## Solicitation Addendum

Addendum No.: 2  
Solicitation No.: 24-TA004973SAM  
Project No.: 008896  
Solicitation Title: SR 70 / 15<sup>th</sup> ST. E. Water Main Relocation  
Addendum Date: November 22, 2023  
Procurement Contact: Sherri Meier

Bid Attachment 6, Isolation Valve Map

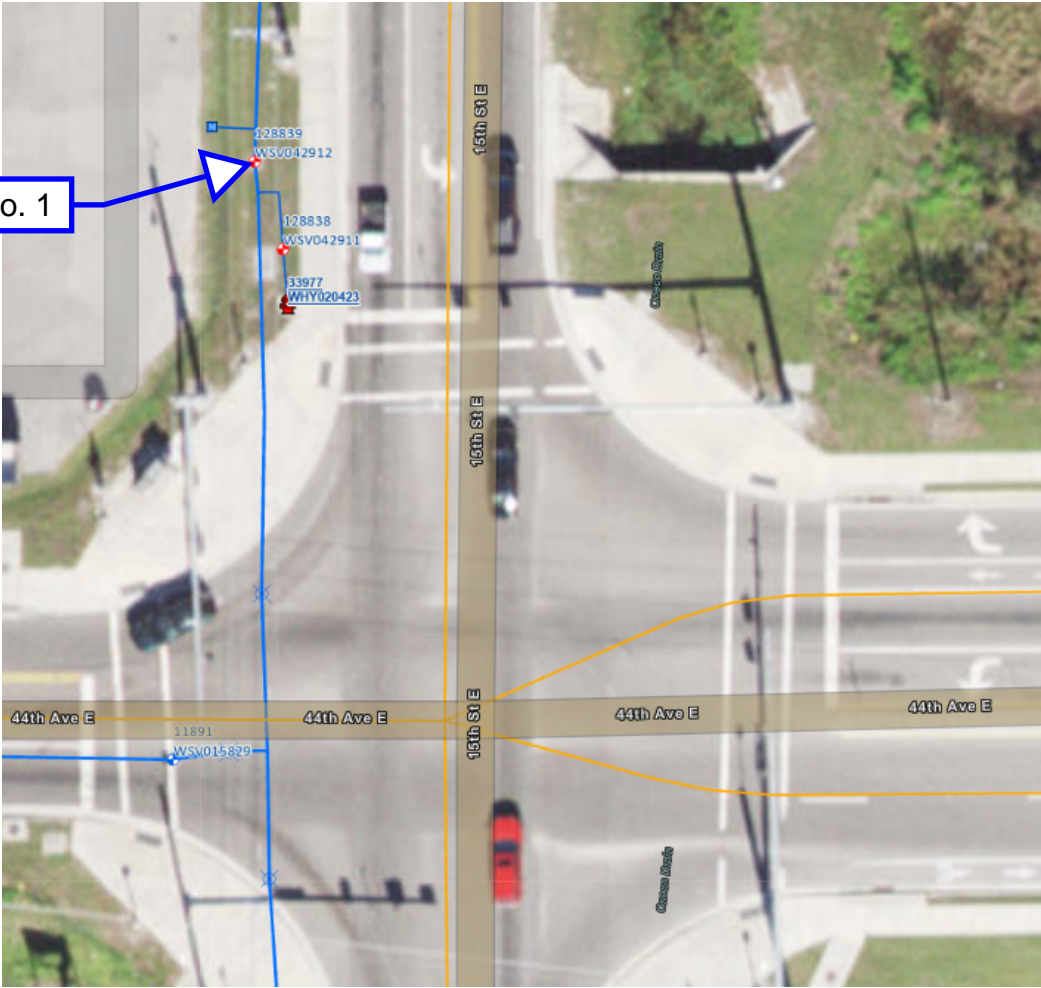
**Q2. Please provide the locations of the nearest 24” valves for the purpose of isolation for the new main tie ins to the existing water main. (Distance between valves?)**

R2. Attached is an exhibit of the closest isolation valves. The distance between valves is approximately 1,300 ft.
